## Computer Monitors Service Bulletin

**Model:** GDM17SE1, GDM20SE1

**Subject:** Significance of LED Flashing during a Shutdown **Date:** May 27, 1994

**Subject:** Circuit Improvement

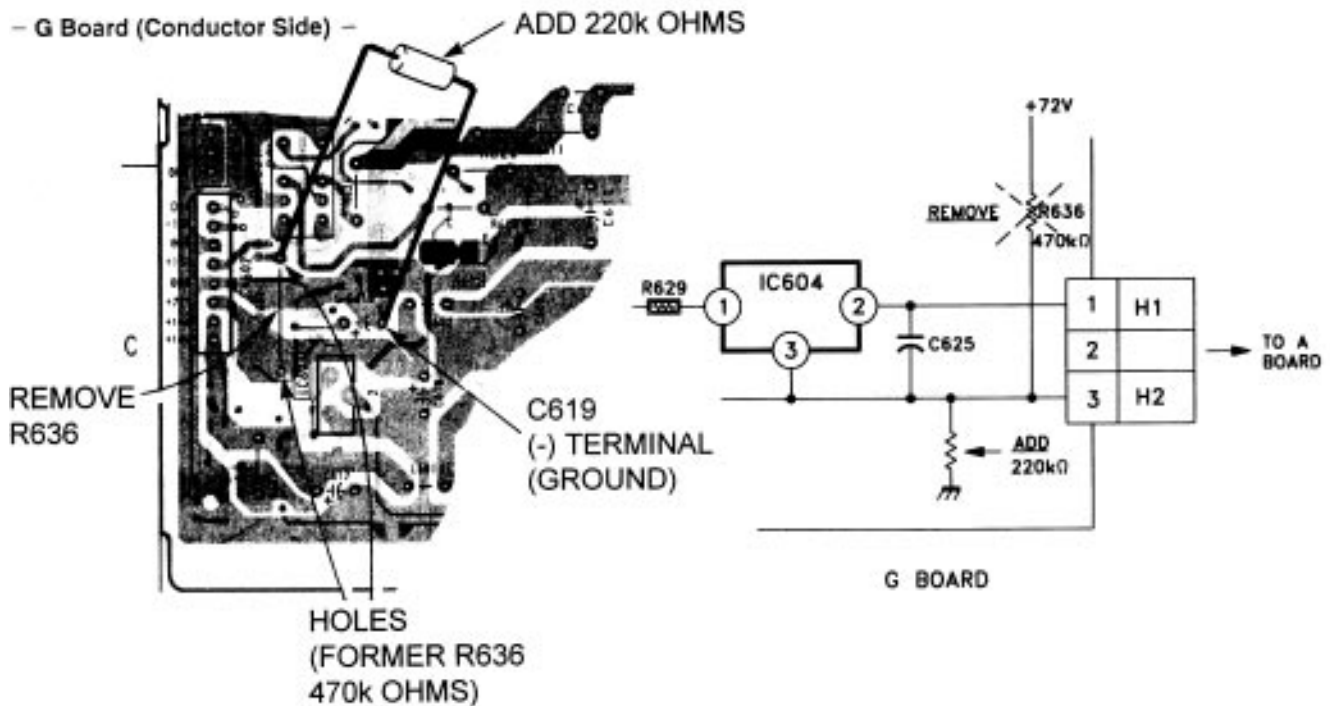
**Symptom:**  
(231) Countermeasure against possible arcing

1. Remove R636 from the G-Board.
2. Add new Resistor (220K $\Omega$ , ½ Watt, P/N: 1-202-842-11) between R636 and C619 lands as illustrated below.
3. Fix resistor in place by applying RTV.

**INPUT TERMINAL BOARD**

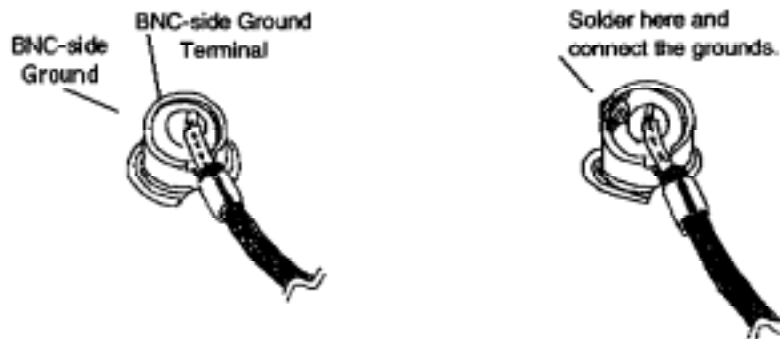
The unit has noise in the picture or a color is missing. The picture may be unstable or have intermittent no picture symptoms. The BNC Input connectors may have deteriorated contact points.

If the customer complains of this symptom, then please check the condition of the BNC connectors on the Input Terminal Board. Refer to the following illustrations.

If needed, solder each of the BNC input connectors as shown below.

Repeat with each connector (R, G, B, HD, VD).

**Subject:** Countermeasure for dimming picture

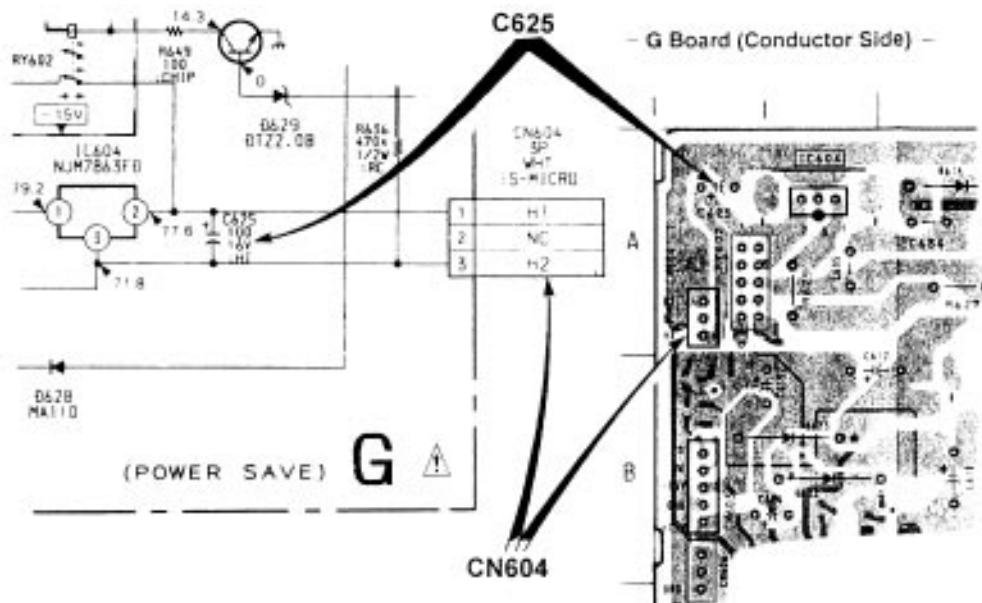
After a while, the picture dims and eventually disappears completely

Do not replace the Picture tube nor the Power Supply board (G-Board). Instead please check C-625 first.

C-625 is located on the G-board and it is the main filter for the CRT heater voltage. In some rare cases visual inspection will reveal an inward indentation on the top of the capacitor. This indentation causes the heater voltage across the CRT to drop due to cap failure. Replace the Capacitor.

If this is not the case, check the heater circuit for normal operation. CRT confirmation may be done by disconnecting CN604 (heater voltage) and applying an external regulated 6 volts DC directly to H1 and H2 on the A-Board.

**Subject:** Countermeasure for High Pitch Squeal

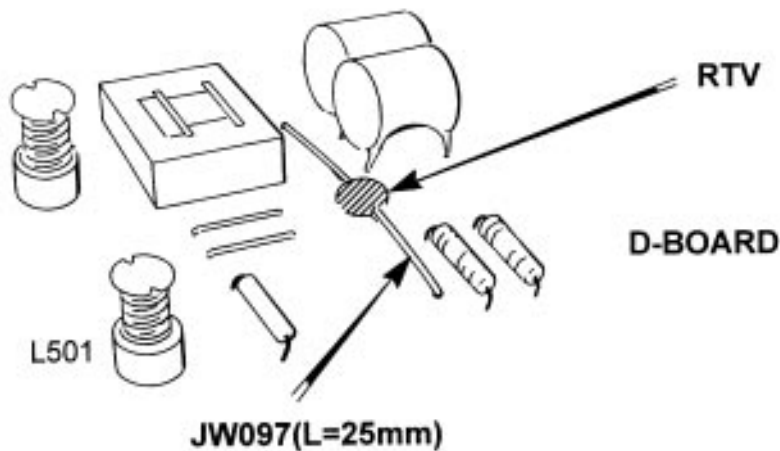
A high frequency squeal is audible when using the MAC 16" Mode

The noise comes from JW097 (jumper wire). JW097 vibrates due to L501 (Horizontal Linearity Coil). To confirm the noise source, touch the center of JW097 using a plastic adjustment tool.

If the Noise is confirmed, apply RTV in the middle of the jumper wire as illustrated below:

JW097 is located in the middle of the D-Board near L501 and T502.

**Subject:** D824 Improvement

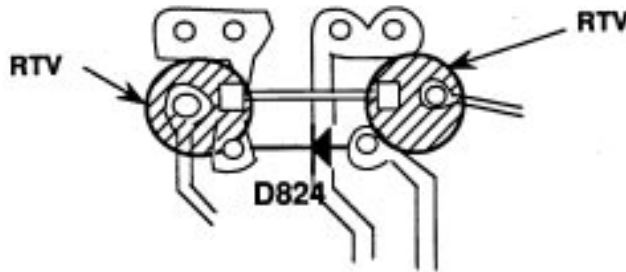
**(131)** No Picture due to HV shutdown

**Solution:** Please check D-824 on the D-Board. If shorted, replace as follows:

1. Replace D824 with a 1SS83 type

2. Apply RTV to locations illustrated below:

**Subject:** Deflection Circuit Improvement

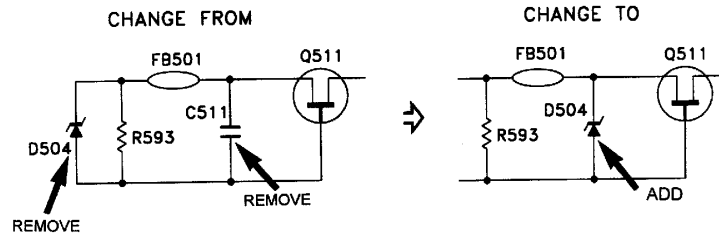
No operation, Front Panel LEDs are flashing

- 1 Check Q-511, Q-512, PS-500 (Fuse link) and C-548.
- 2 Replace the above items if necessary.

- 3 Remove C-511.
- 4 Remove D-504 and mount it to the C-511 lands.

Subject: Failure of Q511 on D Board due to CRT Arcing      Date: August 8, 1995

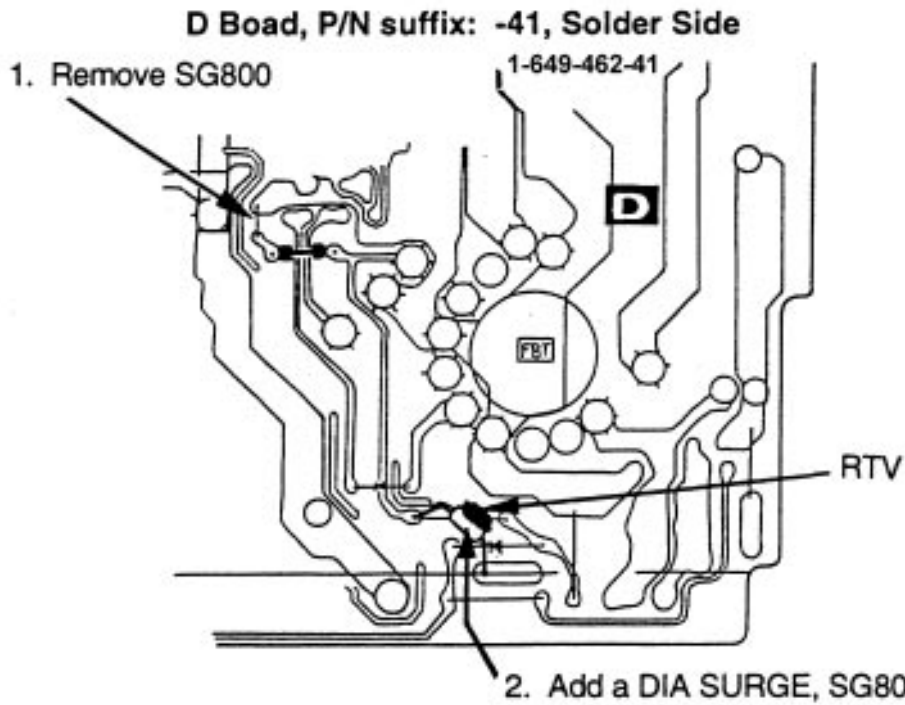
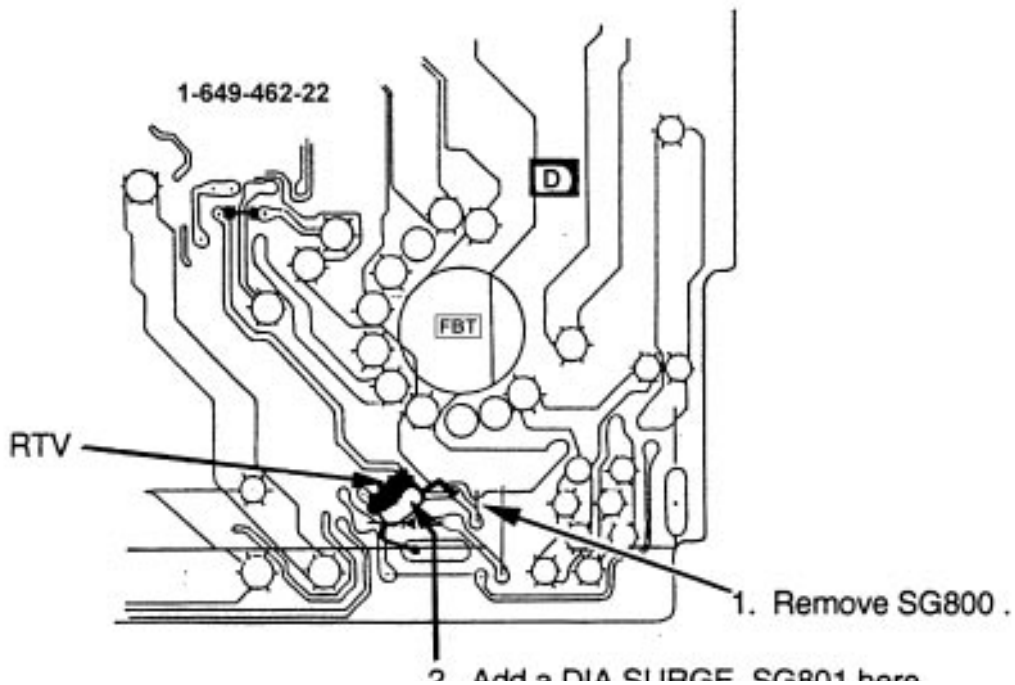
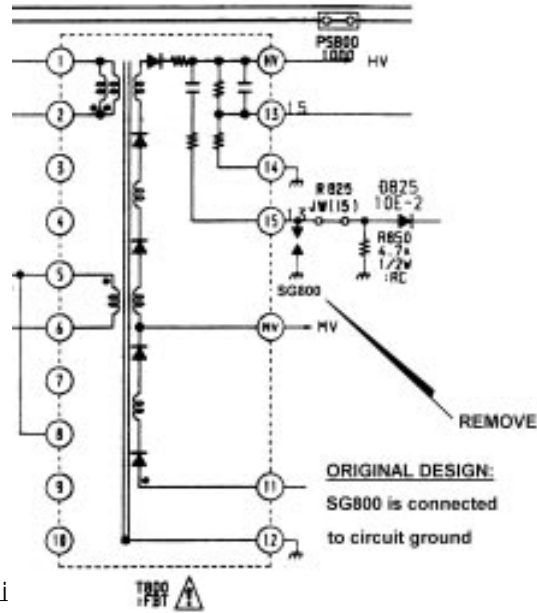
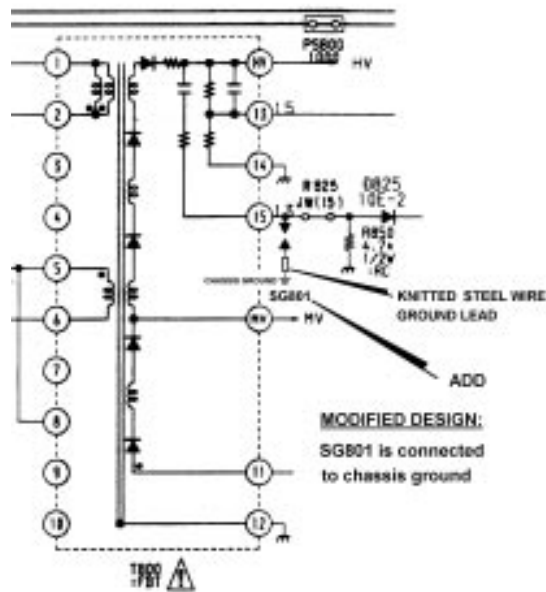
Symptom: (131) No picture. Scan failure. Q511 failure on D Board .

Solution: In addition to Q511 replacement, Remove SG800 and add SG801 in new location on D Board as described below. This will protect Q511 from CRT arcing.

Procedure to remove SG800 and add SG801. See Figure below.

1. Remove SG800 Spark Gap.
2. SG801 will be soldered on the Soldering side of the D Board. Cut the leads of the SG801 as necessary. Solder one lead of SG801 to the land of R825. Solder the other lead of SG801 to the land of the Heatsink as shown.
3. Fix the body of SG801 to the D Board on the board near the FBT ground with RTV or similar adhesive.

Perform modifications as shown according to the applicable foil pattern.

Schematic diagram changes.

Original Design: SG800 is connected to circuit ground.

Modified Design: SG801 is connected to chassis ground.

#### IC604 MARKINGS

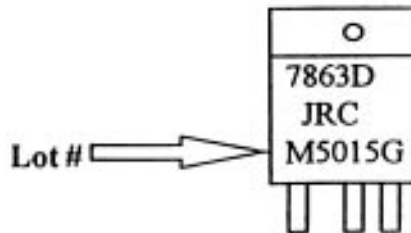
If the screen is dark, this may be due to loss of CRT heater voltage caused by IC604 failure on the G Board. Effected units have IC604 marking shown in the illustration below. Units with IC604 corrected have green labels affixed to the G Board shield case and to the information label on the rear panel.

1. Check the Lot No. on IC 604. See illustration below.

2. If the Lot No. of IC604 is "**M5015G**", then replace IC604 with the new component.
3. If IC604 was replaced, then mark the unit by affixing a small (6-10 mm) green label to the G Board shield case. Also, affix a small (6-10 mm) green label to the information label on the rear panel of the unit.

**D Board Layout: C460, C461, D426 Connections to IC404.**

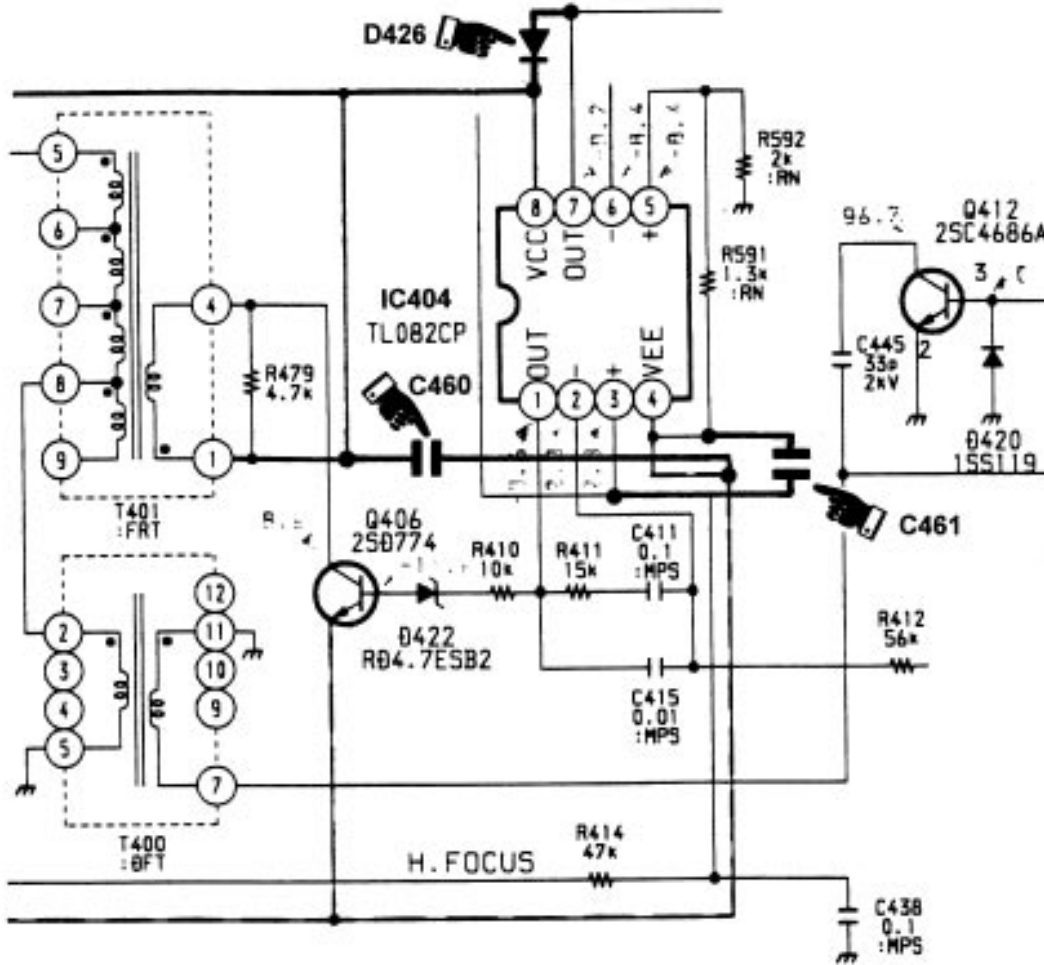
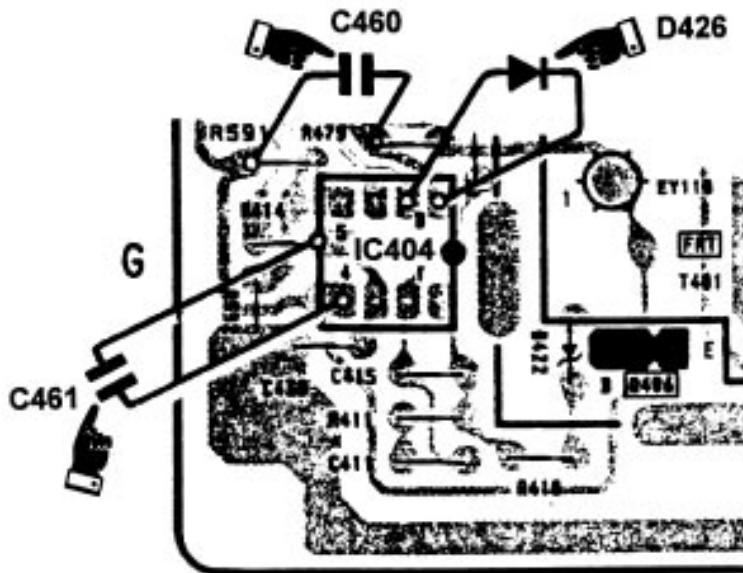
Picture out of focus along the side or in random areas. Failure of dynamic focus circuits is caused by damaged IC404 on the D board.

IC404 is damaged by energy of CRT arcing at G4. Replacing IC404 will restore dynamic focus function. Adding two new capacitors and one new diode to the IC404 circuit will reduce the arc energy reaching IC404.

D Board Schematic: C460, C461, D426 added to IC404.

1. Replace IC 404 on the D Board.
2. Install C460 as a new part. Cut leads to about 0.5" length. Solder tack one lead to IC404 Pin 4 at the R591 solder pad. Solder tack the other lead to IC404 Pin 8 at the R479 solder pad.
3. Install C461 as a new part. Cut leads to about 0.4" length. Solder tack one lead to IC404 Pin 3 at the R414 solder pad. Solder tack the other lead to IC404 Pin 4 solder pad.
4. Install D426 as a new part. Cut leads to about 0.4" length. Solder tack the anode lead to the IC404 Pin 7 solder pad. Solder tack the cathode lead to IC404 Pin 8 solder pad.
5. Secure C460, C461, D426 component bodies to PCB surface with RTV as needed.
